NONCONFORMANCE-REPORT LOG & STATUS BOOK

PROJECT NO. 7220

NONCONFORMANCE REPORT

QUALITY AUDIT FINDING

SKETCH ATTACHED Yes 7220-FSK-C-14

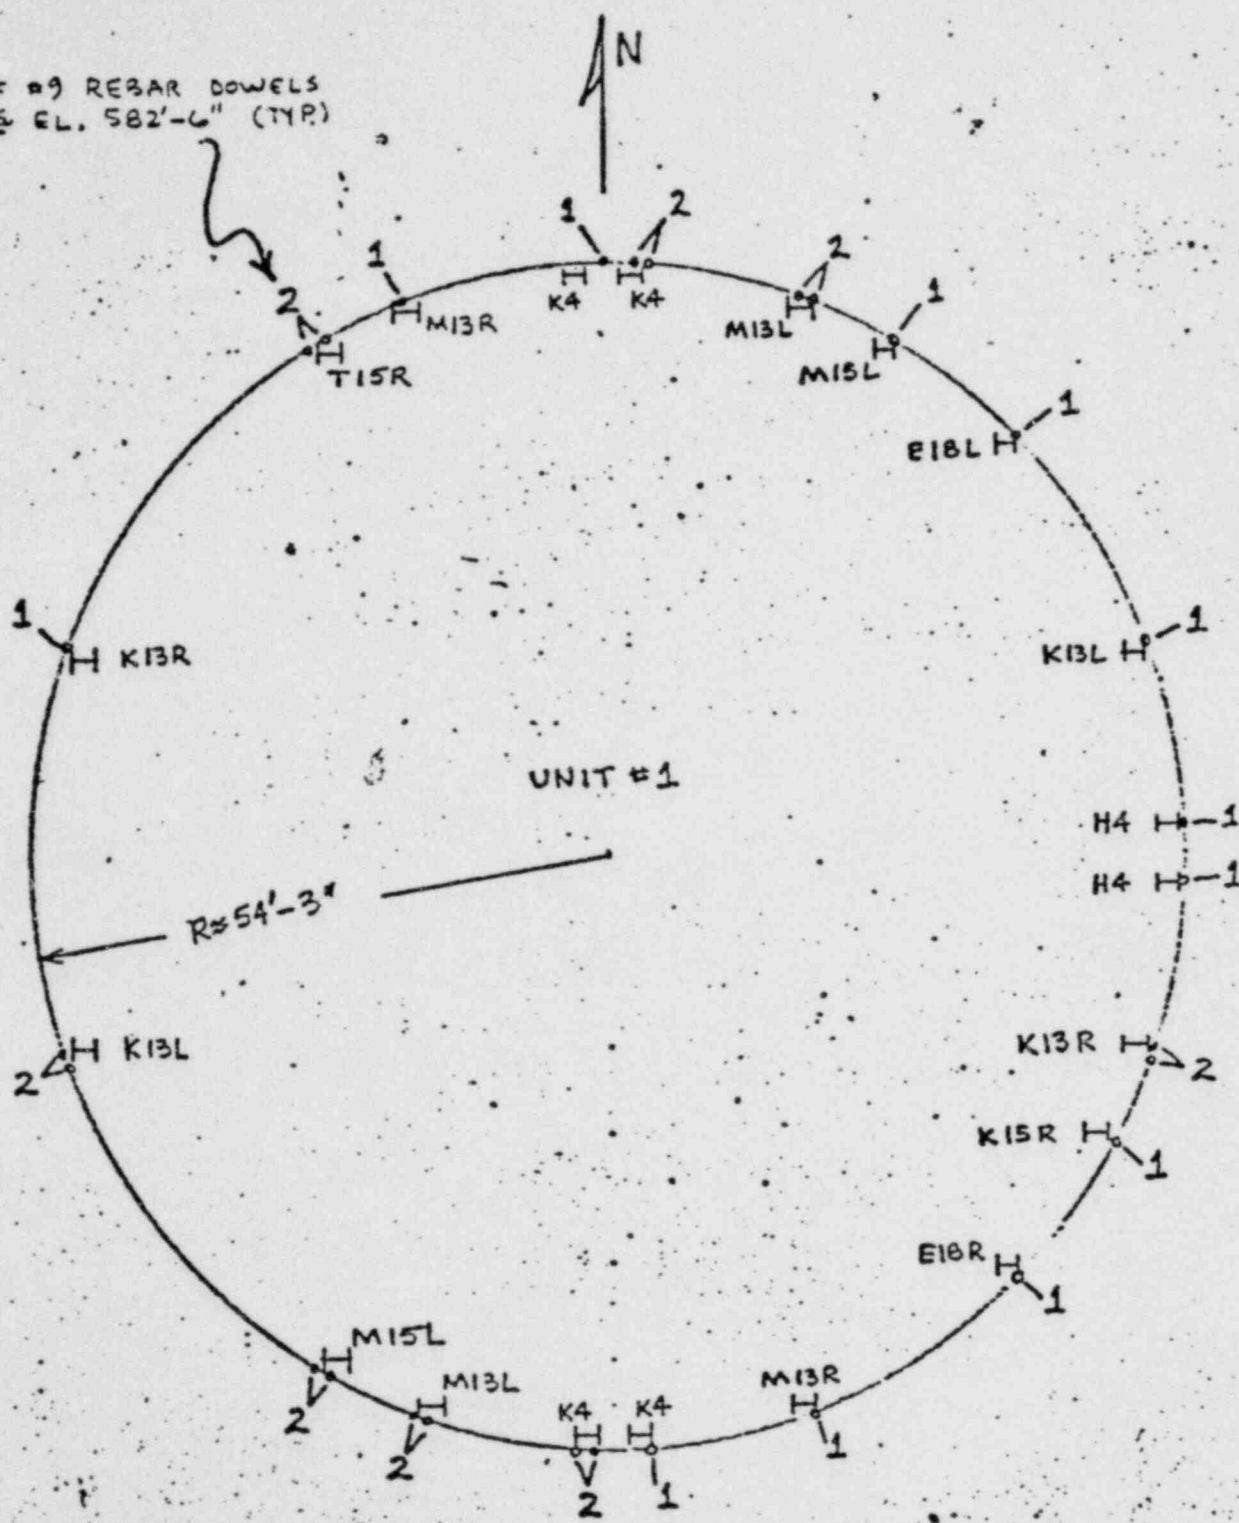
1 Twenty-eight #9 rebar dowels extending from the tendon gallery inner wall to the Reactor Building #1 base slab were cut off at the concrete line (582'-6") in order to set certain columns for the support framing system. See attached 7220-FSK-C-14 for locations. See sheets 1 & 2 of Joseph T. Ryerson & Son, Inc. drawing SW 528626 for column identification.

NUMBER OF #9 REBAR DOWELS CUT OFF @ EL. 582'-6" (TYP.)

TOTAL NUMBER OF DOWELS INSTALLED — 457
 TOTAL NUMBER OF DOWELS CUT OFF — 28

N R # C-4

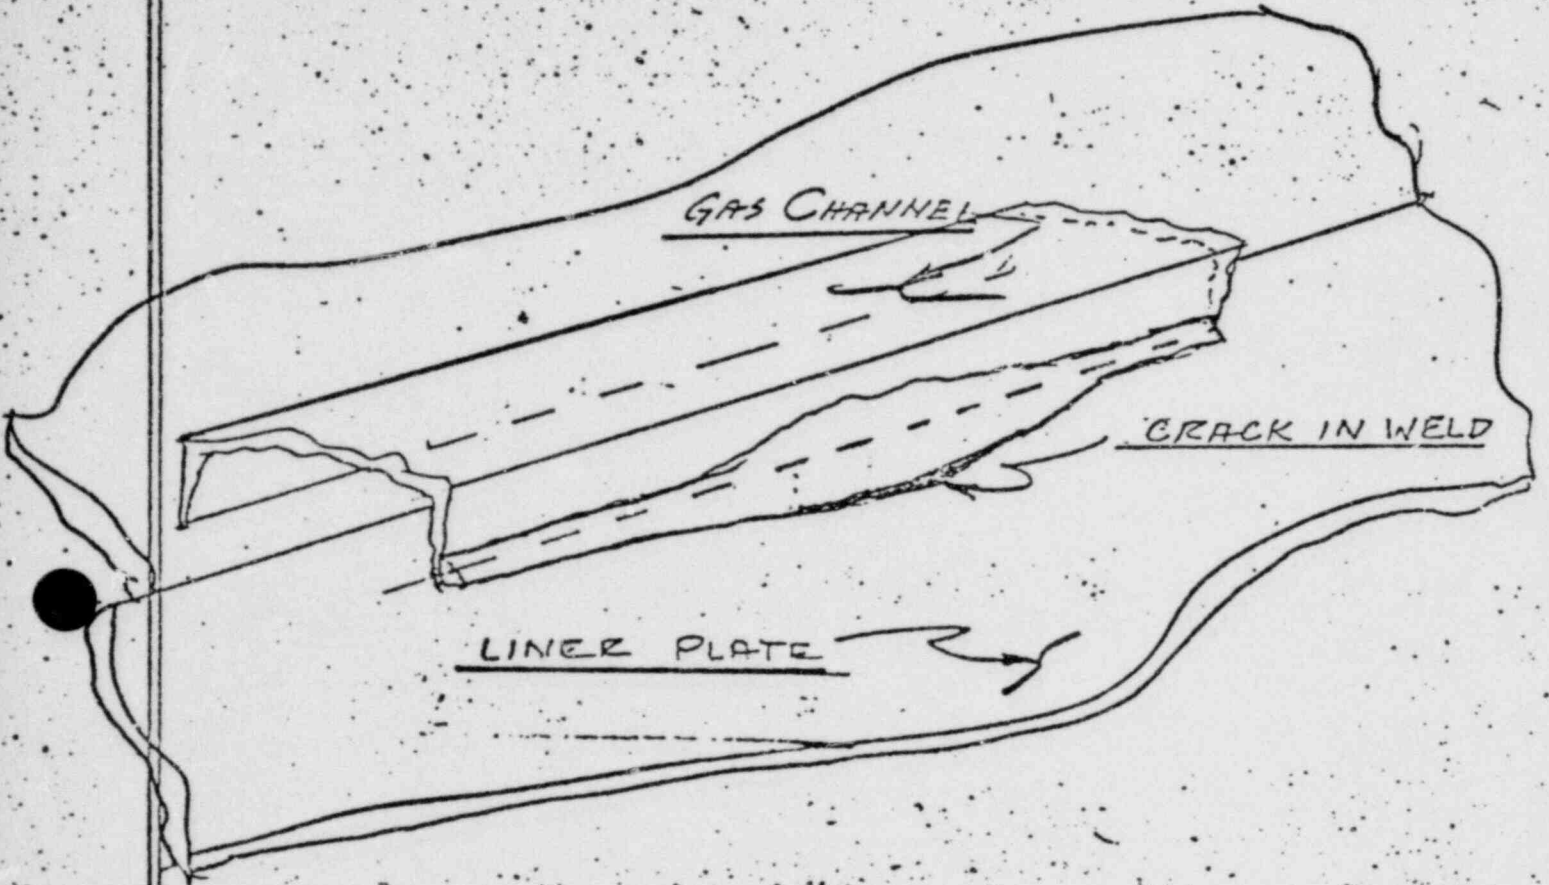
10. No.	11. NONCONFORMANCE (DISCREPANCY) DESCRIPTION: (LIST SERIAL NUMBERS WHERE APPLICABLE)	ASME YES <input type="checkbox"/> NO <input checked="" type="checkbox"/>
<u>1</u>	<u>S-1-5-2-1 Liner Plate</u> <u>Excessive weld metal was applied when attaching the 2" gas channel over the weld joining the two 40'-0" Liner Plate to make one 80'-0" Plate assembly. Part of the weld cracked after the assembly was prime coated. (See attached sketch.)</u>

Field Recommendation:
Remove defective weld by grinding. Visually inspect channel and plate for further defect. Reweld in accordance with specification 7220-C-50. Test with liquid penetrant, and pressure test per C-50.
